PCN – Process Change Notification

Change:	CGGP.35.3.A.02
Date:	2016/09/01
Author	Bonnie Chen

Model#	Part Number	Changes
35mm GPS/GLONASS Ceramic Patch	CGGP.35.3.A.02	Amend dimension of pin length.
		Amend Package.
		Add Raw Materials P/N.

Illustration of Change

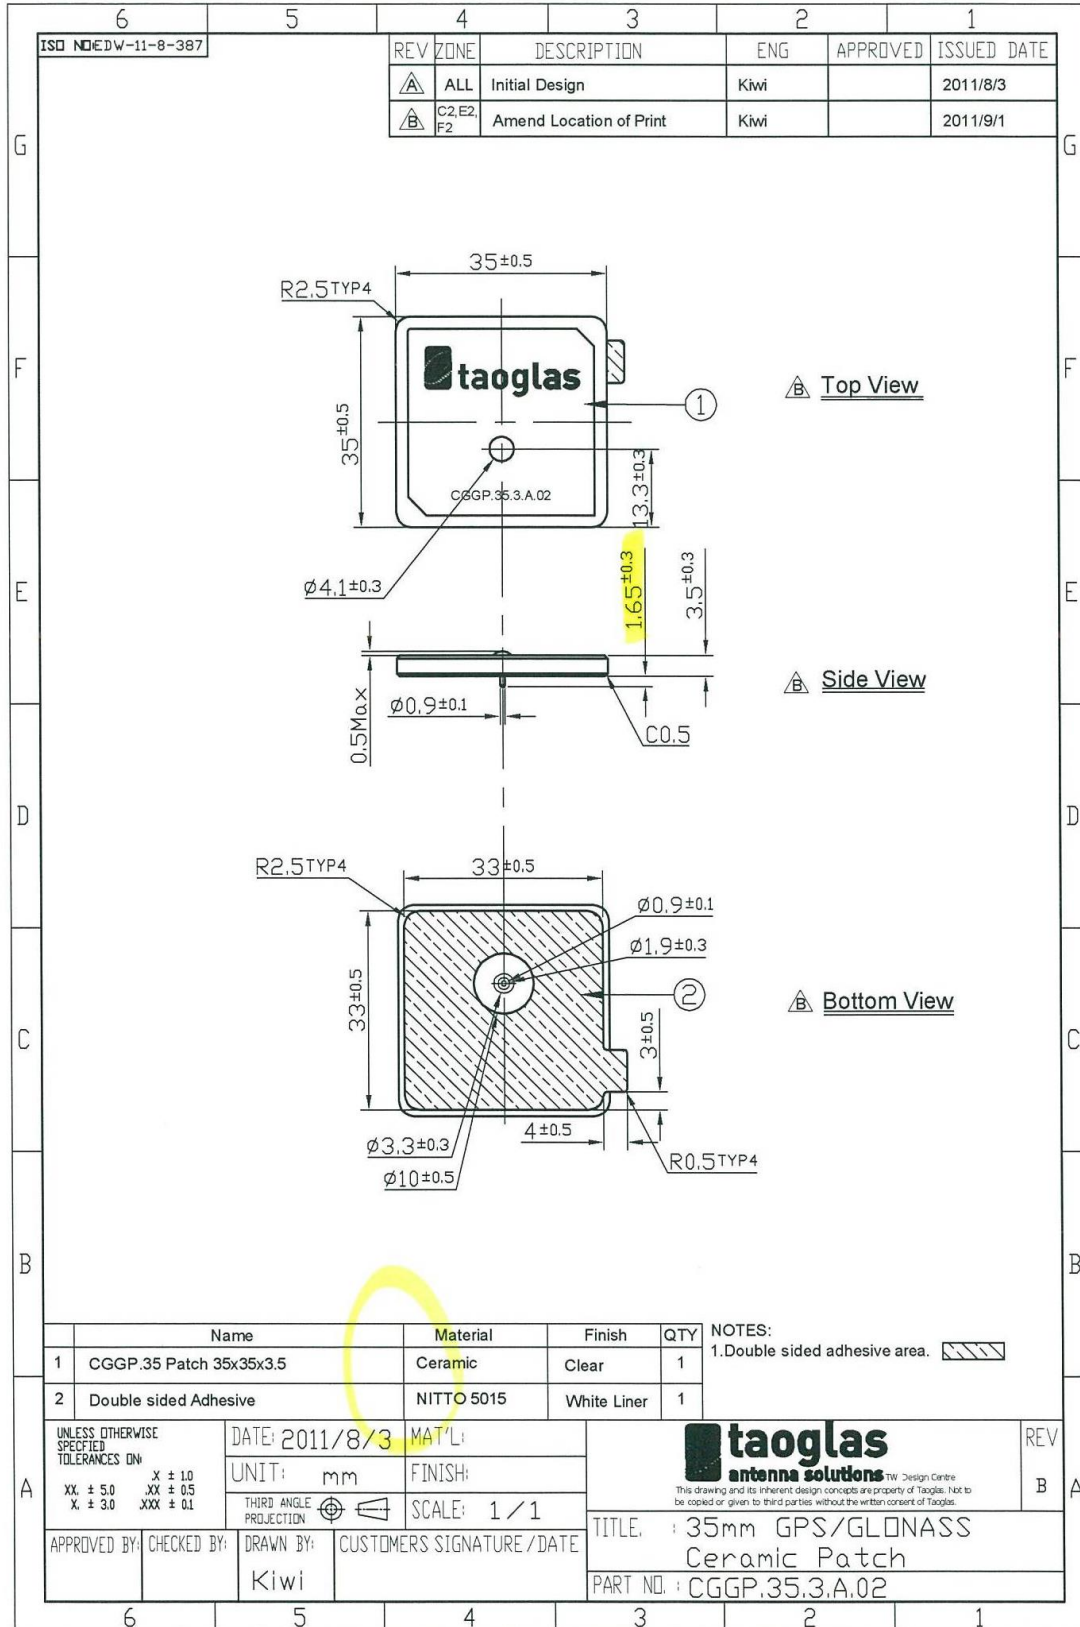
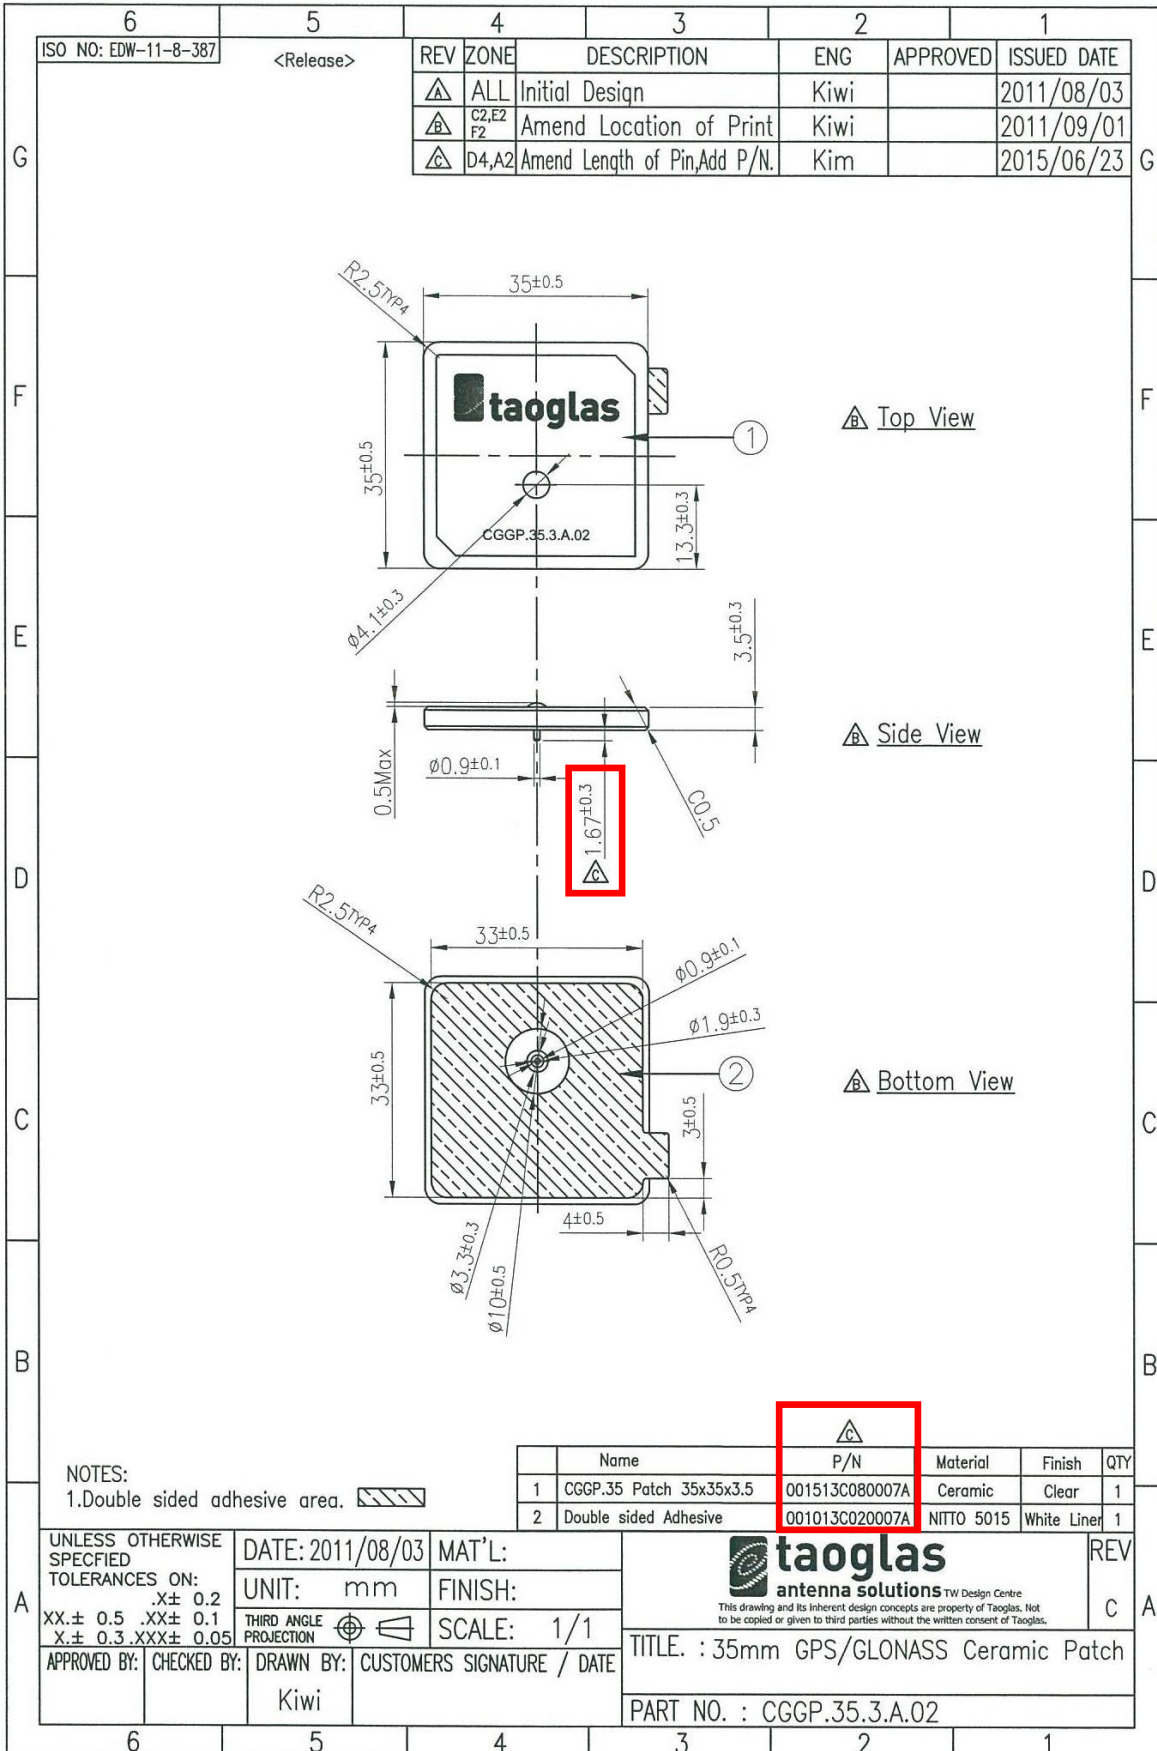
1. Amend pin length from 1.65 to 1.67mm.
2. Amend package.
3. Add P/N.
